# Access Compliance Report

## Public Rights-of-Way

Intersection ID: 11262	Main Street: EASTWAY_DR	Cross Street: FRONTENAC_AV	Location: NW
ADA ID: C6D9AA6DBD75	Ramp Type: IslandPerp	Initial Pass/Fail: Fail	Overall Compliance: No
Severity Score: 1.25			
Codes/Mitigation Info/Possible Solution		Field Measurements/Component Compliance

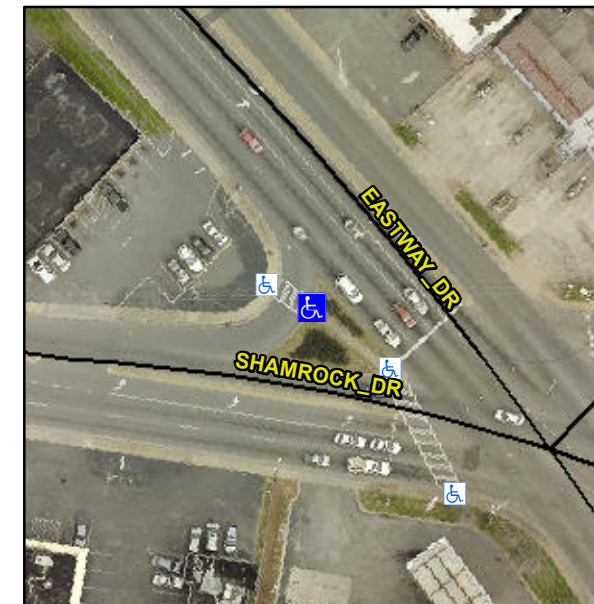
**Not Found, R304.5.3**

Compliance	Description	Data	Compliance	Description	Data
N/A	Ramp Length (in)	76.0	Yes	Ramp Slope (%)	7.6
Yes	Ramp Width (in)	65.5	No	Ramp XSlope (%)	4.5
N/A	Flare Type LT	N/A	N/A	Flare Type RT	N/A
N/A	Flare Slope LT (%)	N/A	N/A	Flare Slope RT (%)	N/A
N/A	Flare Traversable LT?	N/A	N/A	Flare Traversable RT?	N/A
N/A	Landing Length (in)	N/A	N/A	DWS Provided?	N/A
N/A	Landing Width (in)	N/A	N/A	DWS Contrast?	N/A
N/A	Landing Slope (%)	N/A	N/A	DWS Length (in)	N/A
N/A	Landing X Slope (%)	N/A	N/A	DWS Full Width?	N/A
N/A	Landing Curb? (Y/N)	N/A	N/A	DWS Offset (in)	N/A
N/A	Shared Landing?	N/A			
N/A	Gutter Ponding?	N/A	N/A	Gutter Slope (%)	N/A
N/A	Gutter Lip Ht (in)	N/A	N/A	Gutter X Slope (%)	N/A
N/A	Painted X Walk1?	Yes	N/A	Painted X Walk2?	N/A
	X Walk 1 Direction	To NW		X Walk 2 Direction	N/A
N/A	X Walk 1 Width (in)	112.5	N/A	X Walk 2 Width (in)	N/A
	X Walk 1 Slope (%)	2.8		X Walk 2 Slope (%)	N/A
	X Walk 1 X Slope (%)	4.4		X Walk 2 X Slope (%)	N/A

**Remove & Replace Entire Ramp.**
